The text reproduced below reflects the state of play of the discussion of the SIG UNR157 up to its 7th meeting on raising the specified maximum speed of ALKS up to 130 km/h. It is based on ECE/TRANS/WP.29/GRVA/2020/32 (DE) and subsequent amendments received on this proposal.

Modifications to the existing text of UN-Regulation No. 157 (incl. suppl. 02 to 00 series) are marked in **black bold** for new or ~~strike through~~ for deleted characters.

I. Proposal

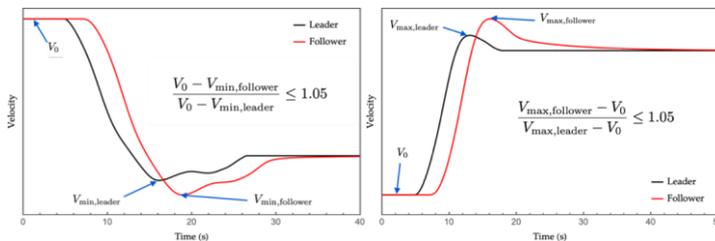
Point of discussion on 5.2.9. and 5.2.10: Agreement to include some aspects of proposals from JRC/EC (UNR157-03-06) on "string stability" as general requirements. Leadership to prepare proposal. → Group needs to review proposal by leadership.

~~[5.2.10 — While following another vehicle the ALKS vehicle shall aim to be string stable.~~

~~In particular, when following another vehicle at constant speed and at a distance such that the speed profile of the ALKS vehicle is influenced by the speed profile of the vehicle in front, the ALKS vehicle shall aim to respond to a perturbation in the speed of the vehicle in front with a perturbation in its speed profile by at most a 5% increase in the maximum difference in speed compared to the vehicle in front before reaching a new equilibrium velocity following the visual examples reported in the following figures.~~

Figure 1
Skilled-Careful-Competent and competent-careful human performance model

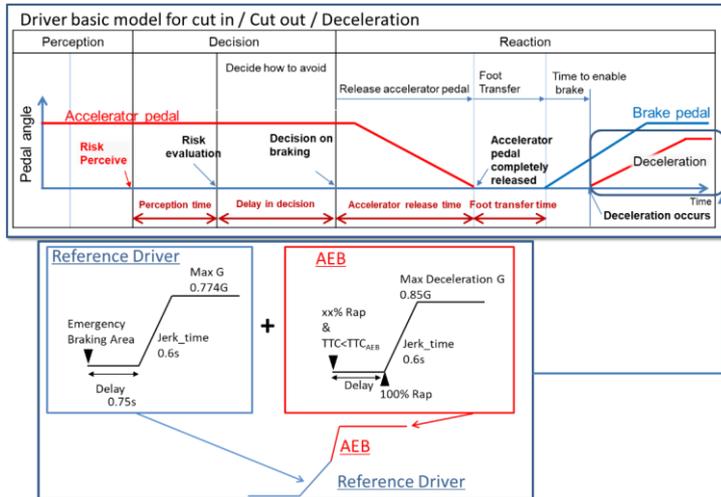
Commented [13]: To be in line with discription in 5.2.7

Figure 2
Driver model for the cut-in scenario

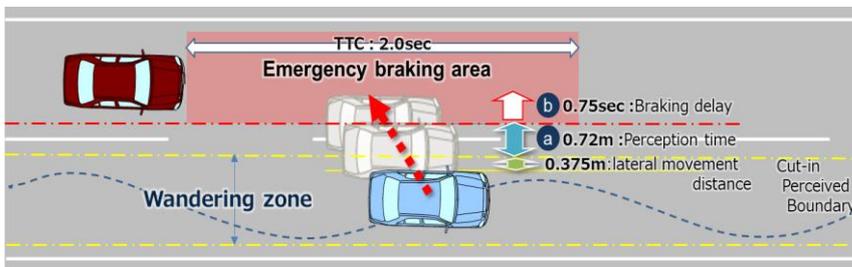
2sec* is specified as the maximum Time To Collision (TTC) below which it was concluded that there is a danger of collision in the longitudinal direction.

~~Note: TTC = 2.0sec is chosen based on the UN Regulation guidelines on warning signals.~~

Figure 3
Cut in scenario

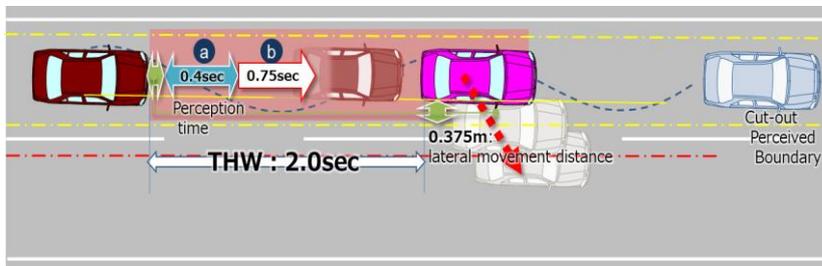
The time 2 sec is specified as the maximum Time Head Way (THW) for which it was concluded that there is a danger in longitudinal direction.

~~Note: THW = 2.0sec is chosen according to other countries' regulations and guidelines.~~

Figure 6
Parameters

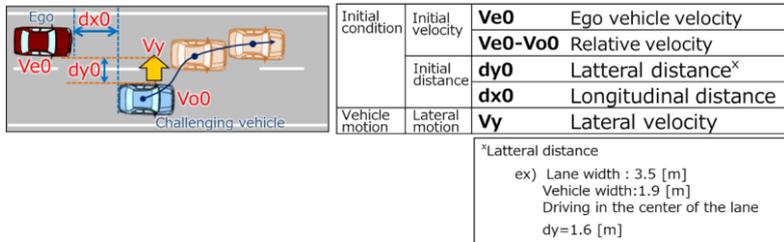
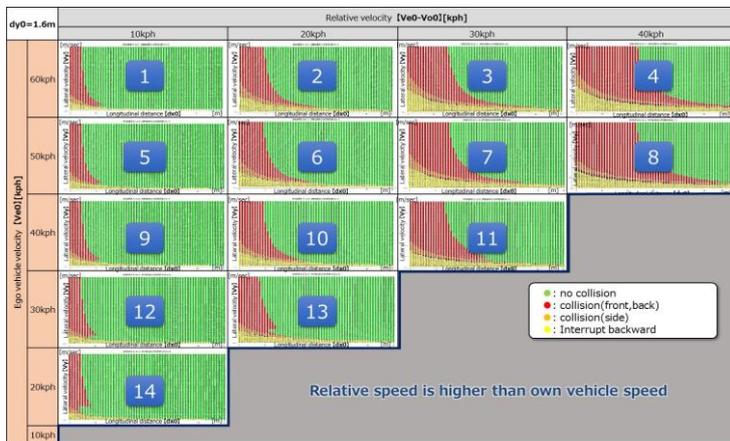
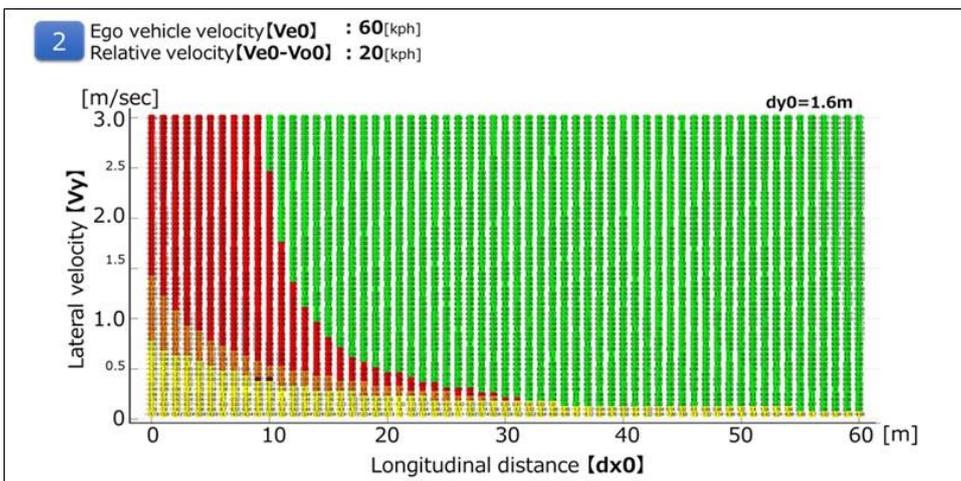
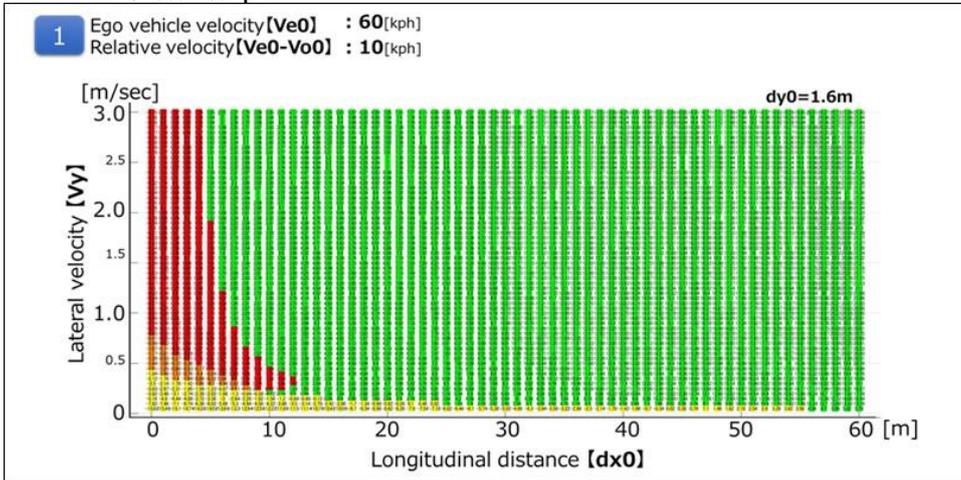
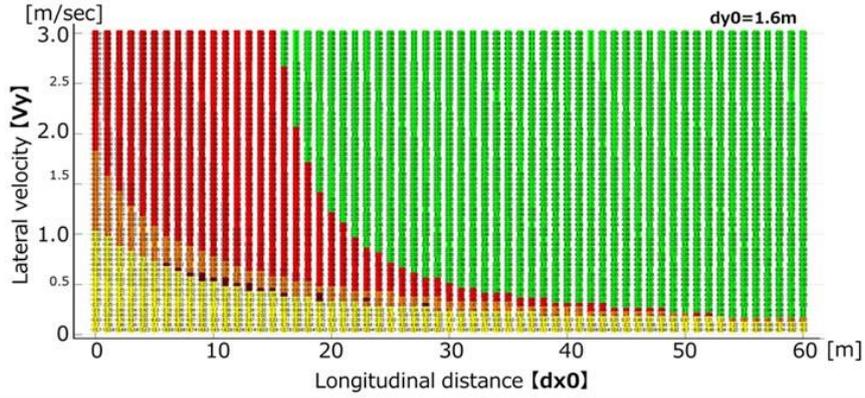
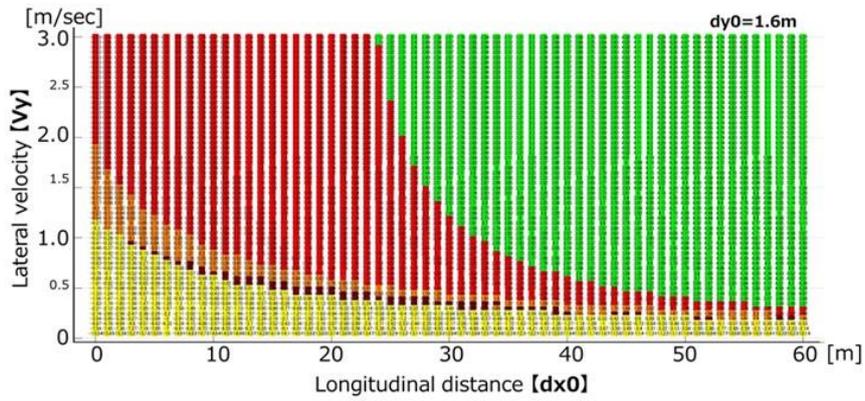
Commented [15]: Japan can accept to delete this section because these are just up to 60kph and just reference. If SIG requests, Japan can make similar figures up to 130kph.

Figure 6
Flow-chart of the second ALKS performance model for the case of the cut in traffic critical scenario

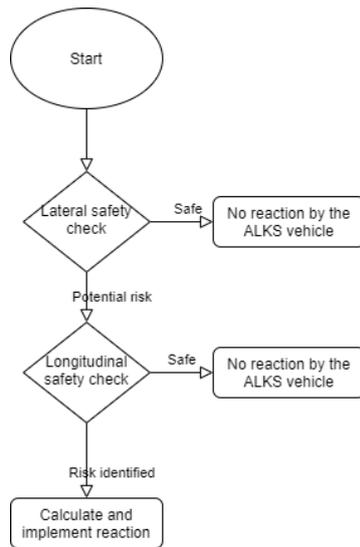
Commented [16]: This amendment is to just for clarification.
